TOWN OF SHELBURNE
SEWER/WATER RELOCATION (AOT WORK)
PLAN AND PROFILE
STA. 303+00 TO 309+00

SHELBURNE VERMONT

C-12

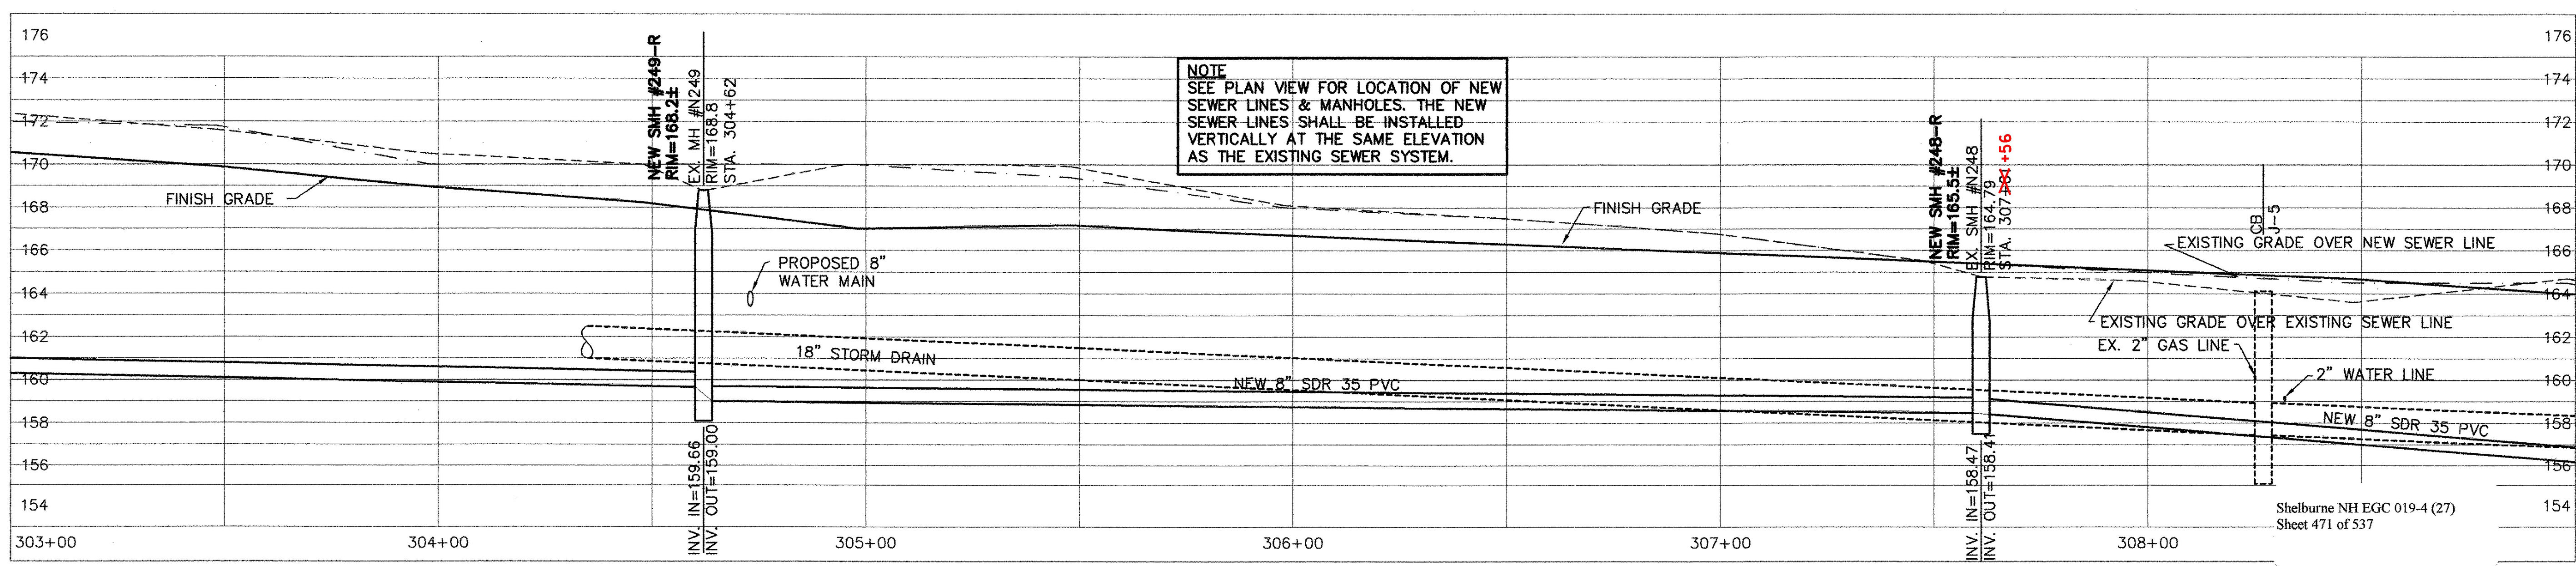
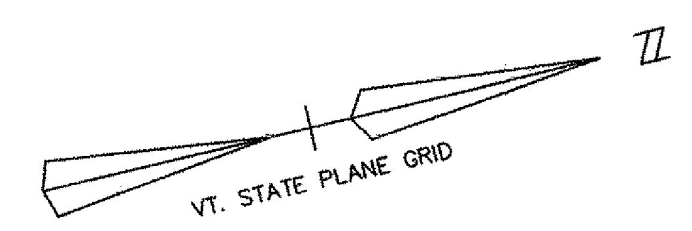
NO.	DATE	DESCRIPTION
1.	11/10/09	FIELD MARK UPS ADDED TO THE PLANS
